Bulletin	Removing the high frequency record boost from early Ampex tape recorders
Applies to	Ampex models 300, 400, 350, and 351 (early versions)
Date	2018 August 2
Revision	1
Total pages	5

Problem

Buletin No: 9-04

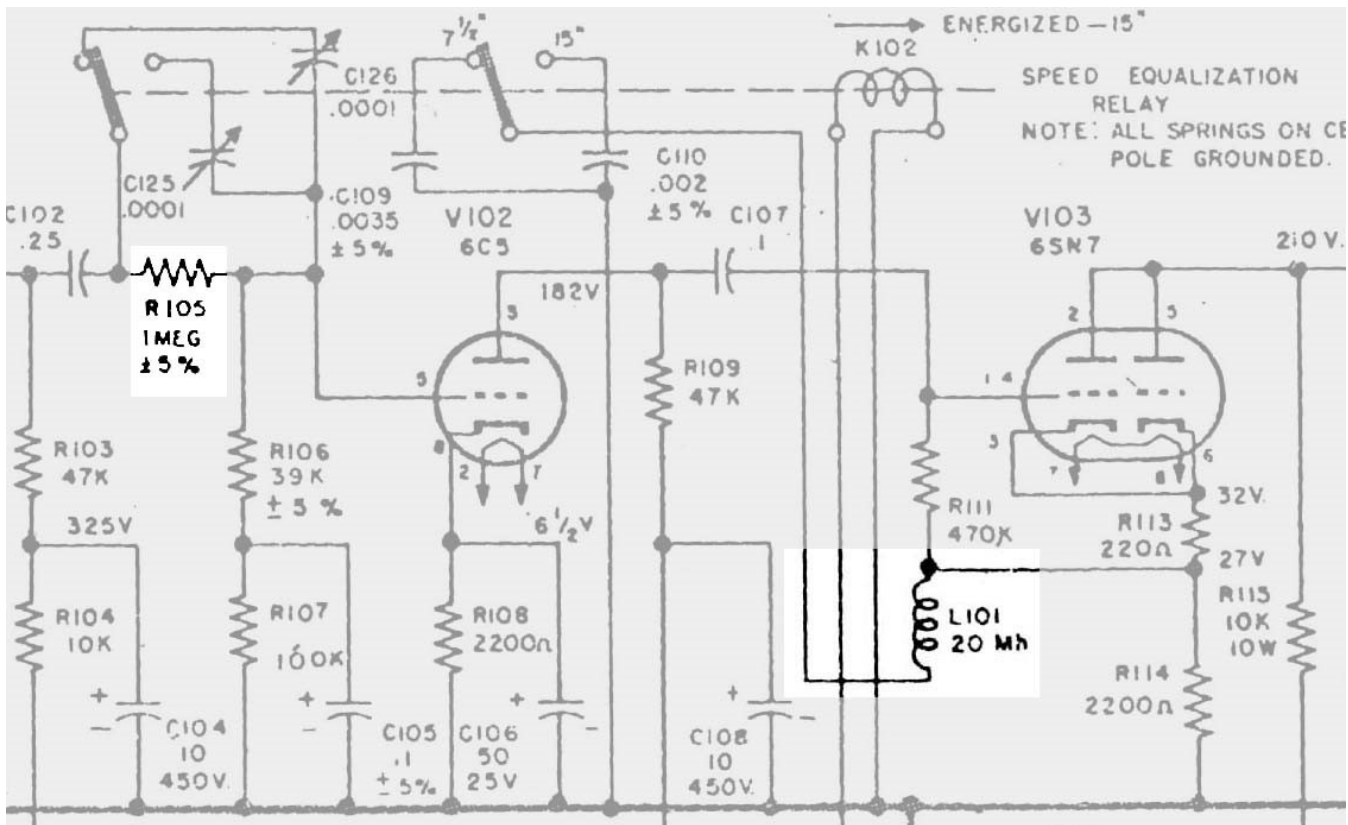
If present, disconnect one end of L101 (20 mH air-core inductor). This component provided additional high-frequency boost and is not needed when using modern tape formulations; disconnecting it removes it from the circuit.

Clip out C110 (.002) and C109 (.0035). These are the two capacitors leading from the long terminal board to the equalization relay. This effectively removes L101 from the circuit as well and, if desired, its leads may be clipped and the coil removed from the board.

Loosen the two screws holding the long terminal board to the chassis. Remove R105 (1 meg) resistor located on the relay side of the terminal board and replace it with a 470K, 1 watt, 5% resistor (Ampex number 041-124). Replace the terminal board on the amplifier chassis. Set the amplifier to the new record curves attached using the test procedure given in the maintenance manual. After installing the amplifier in the recorder, a complete response check of the machine should be made with the same kind of tape which will be used during recording. Some trimming of the record equalization may be required depending upon the tape used.

L401 (Ampex 400, 400A, 401, 401A)

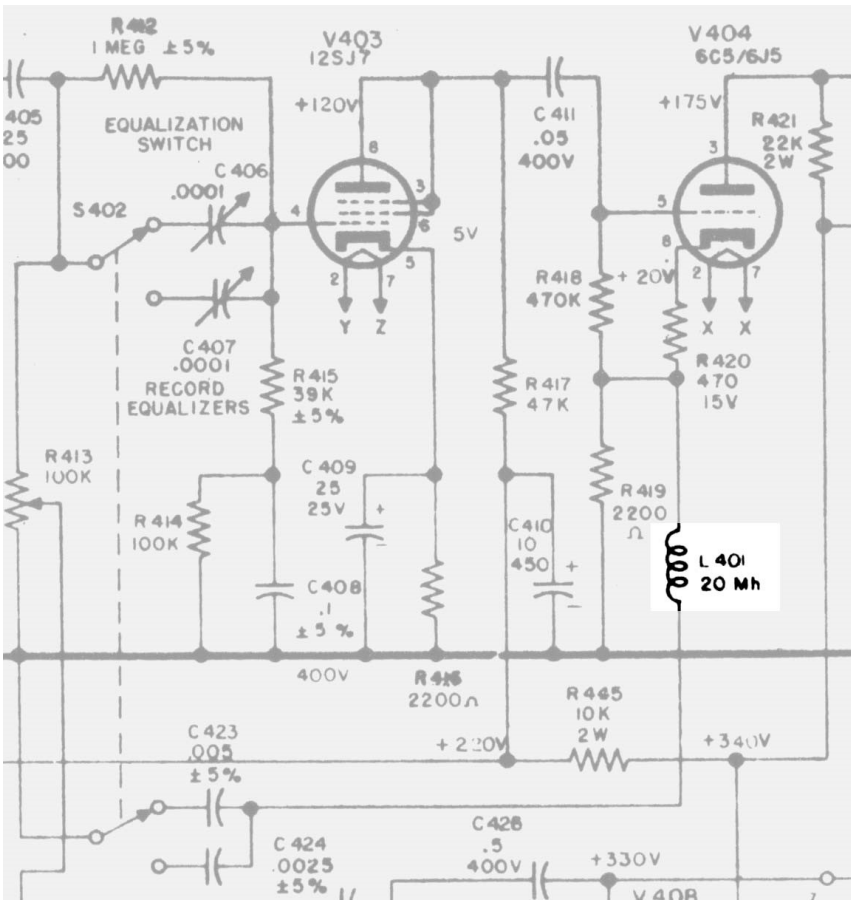
Disconnect or remove L401. This disconnects C423 and C424 which are effectively removed from the circuit.

On the model 400, 400A, 401, and 401A, L401 is on the underside of the chassis (near input transformer T401).

L401
(Ampex 402 and
403)

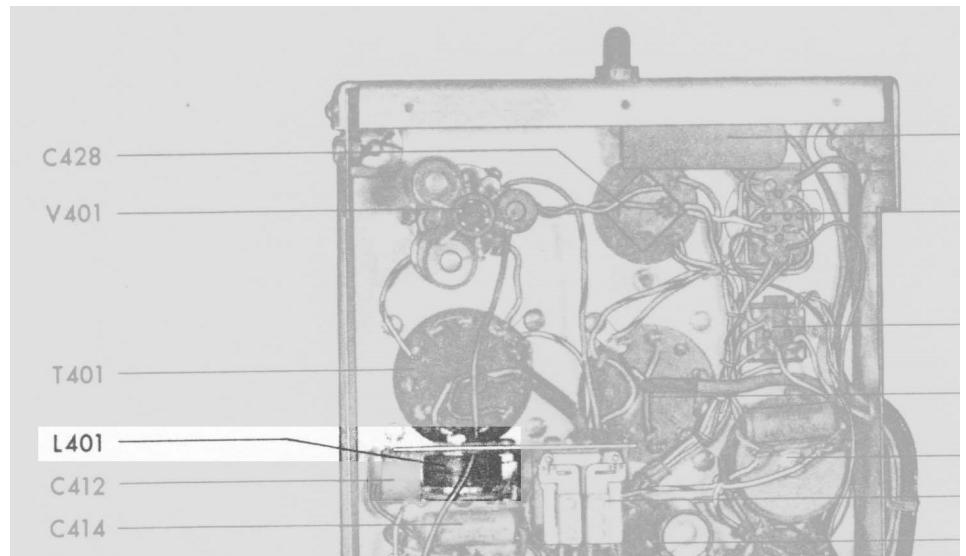
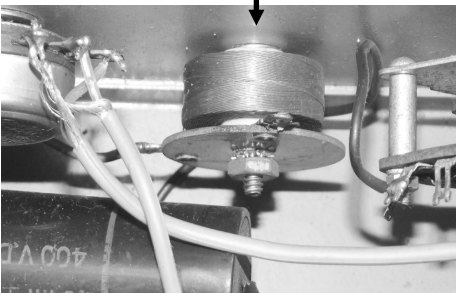
On the model 402 and 403, L401 is mounted on rear of front panel (between input level pot and equalization switch).

L401

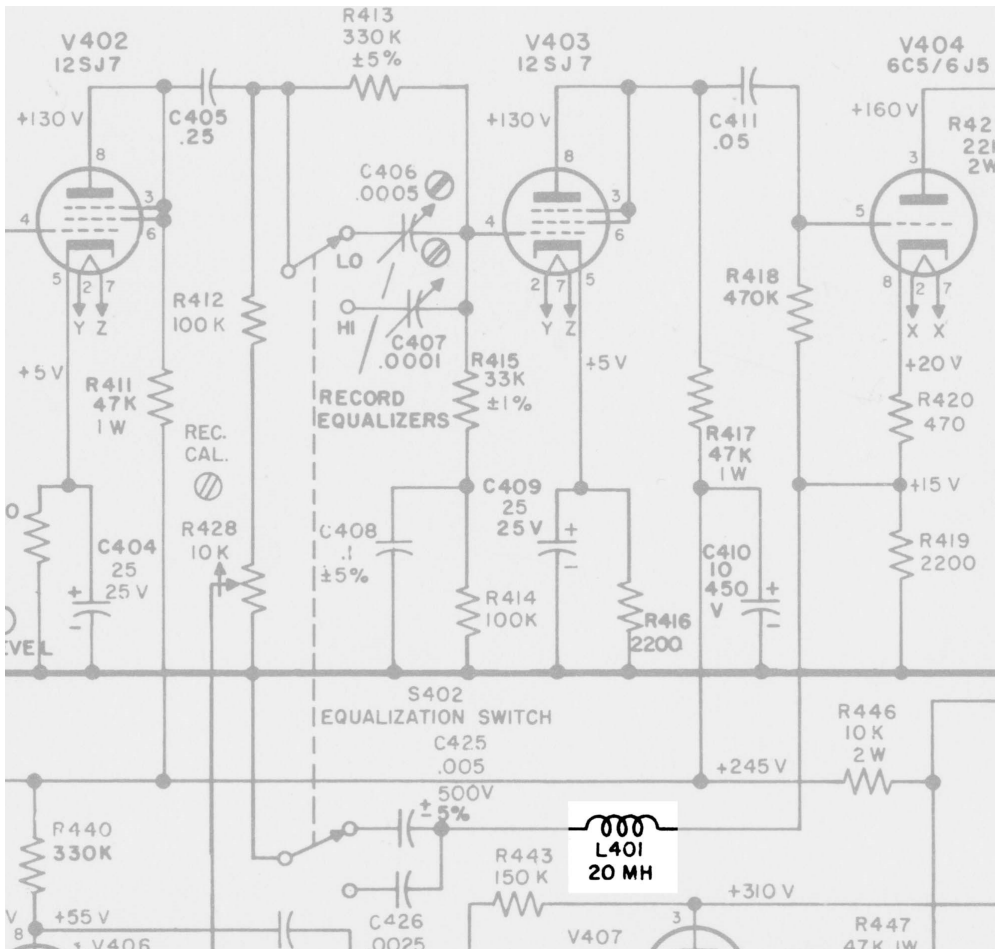
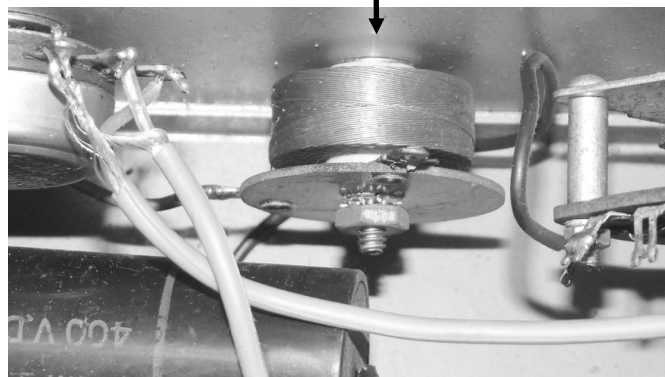
Disconnect or remove L401 (mounted on rear of front panel between input level pot and equalization switch). This disconnects C425 and C426 which are effectively removed from the circuit.
